The Home Depot—Aspen Hill, Site Plan, 820140030

Description

SITE PLAN RECOMMENDATION AND CONDITIONS

Figure 6: 2011 Pedestrian Safety Audit, Connecticut Avenue @ Georgia Avenue Short-term and Intermediate Conceptual Improvements

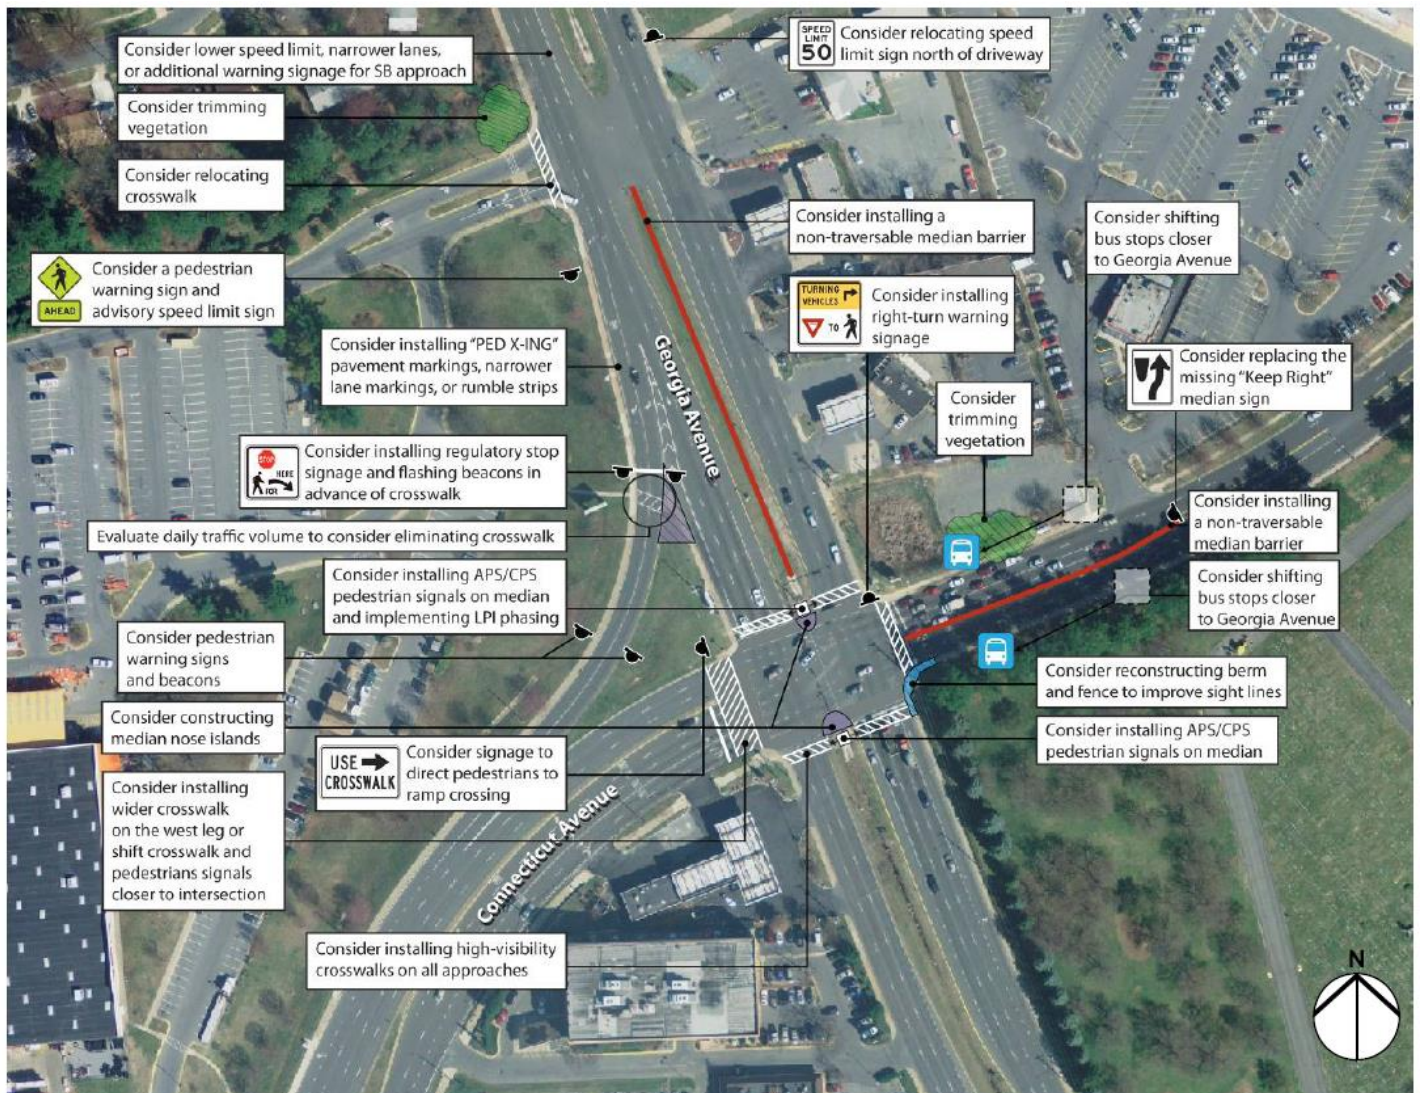
Staff agrees with the State Highway Administration Audit Report assessment that several frontage improvements are necessary to provide pedestrians with safe and adequate travel opportunities through and around the Home Depot Property including the master-planned shared-use path and green corridors enhancements. The Audit Report recommended the following improvements for the Property's frontage and two entrances (Figure 6, below):

1. Evaluate the need for a traffic signal at the intersection of Georgia Avenue and the Home Depot main driveway.
2. Reduce pedestrian crossing distance at the Home Depot entrance at Georgia Avenue.

3. Consider new left-turn restrictions for exiting traffic from 4:00 p.m. to 7:00 p.m. at the Home Depot entrance at Georgia Avenue.
4. Consider trimming tree canopies along Georgia Avenue just north of the main Home Depot driveway at the intersection with Georgia Avenue.

5. Consider construction of a barrier at the back of the sidewalk to protect pedestrians from the drainage structure.
6. Consider installing pedestrian warning signs on Connecticut Avenue south of the site's secondary access driveway.

7. Consider signage changes in the vicinity of the site access from Connecticut Avenue and evaluation of a traffic signal installation including pedestrian signals at the site's Connecticut Avenue entrance.

8. Consider relocating the crosswalk at Georgia Avenue entrance to be closer to its intersection with Georgia Avenue.

9. Consider relocating the 50-mph speed limit sign on the northbound Georgia Avenue side of the roadway to be north of the 7-Eleven driveway (i.e., opposite the Home Depot main driveway).

Staff is recommending that some of the above improvements be made a part of this application's approval (Condition #5); however, recommendation #2 above should be modified to install a "Yield to Pedestrian" sign to alert drivers of pedestrians crossing the Property's entrance at Georgia Avenue, rather than reduce the entrance width, which may impede overall circulation and cause unnecessary congestion.
